## PIMA COUNTY

#### ADDENDUM NO. 1

#### **SOLICITATION NO. 191406 – ELEPHANT HEAD ROAD BRIDGE OVER THE SANTA CRUZ RIVER SUPERSTRUCTURE REPLACEMENT PROJECT**

# **ATTACHMENT 1**

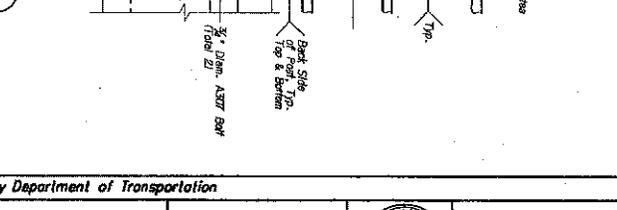
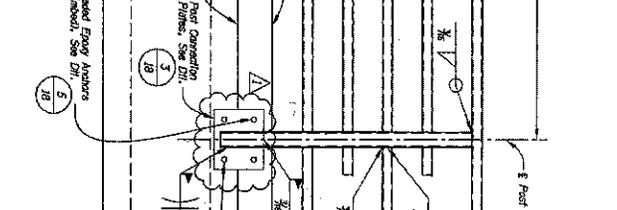
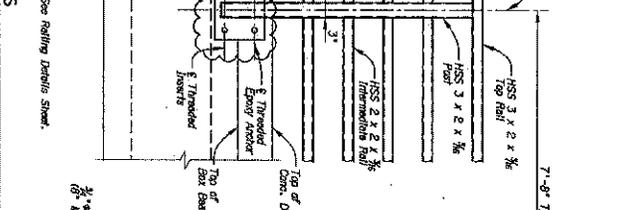
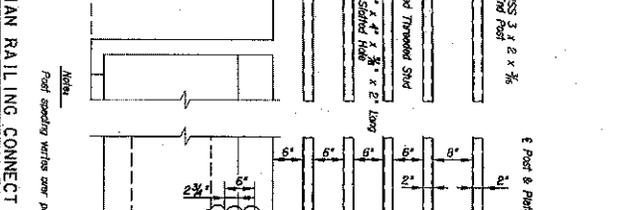
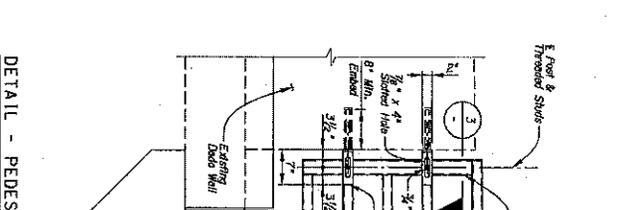
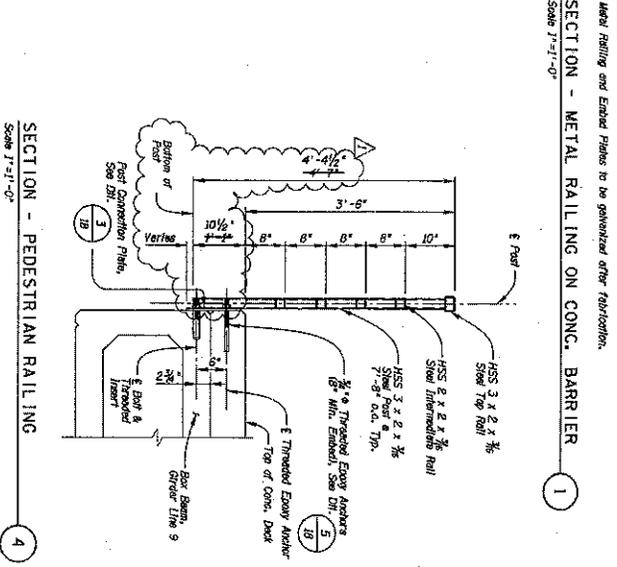
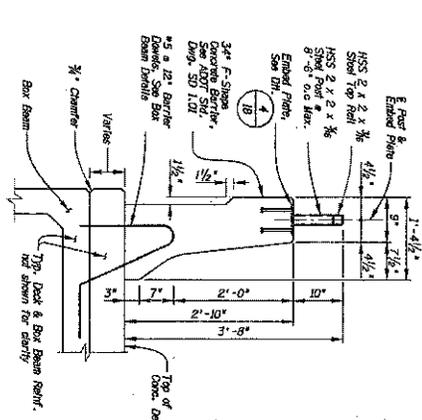
**Q(8)** What type of site preparation is required for TPAC prior to them delivering the girders?

**A)** TPAC has supplied a drawing for site preparation (see Attachment 1, 2 pages, to this Addendum). Also, the Special Provisions show that the slope for the detour and equipment access going into the wash should not exceed 8%. However, TPAC requires that the slope not exceed 7% slope for their equipment and girder delivery.

Crane and truck access is needed into the Santa Cruz River. The trucks will enter the wash from a ramp at the west end of the Elephant Head Road Bridge. The center pin of the crane locations will be centered at the southside of each pier as shown on attached drawing. Truck access will be south of the crane location using a minimum 12' wide road. There needs to be a minimum 70' clear space from the south end of the piers for truck and crane access as shown on the attached drawing. The trucks will exit the wash from a ramp at the east end of the Elephant Head Road Bridge and then turn around and cross back through the wash. Erection will start from the east end of the bridge and work towards the west end of the bridge. All crane pads, and truck and crane access, must be firm and level in order to maneuver under their own power.
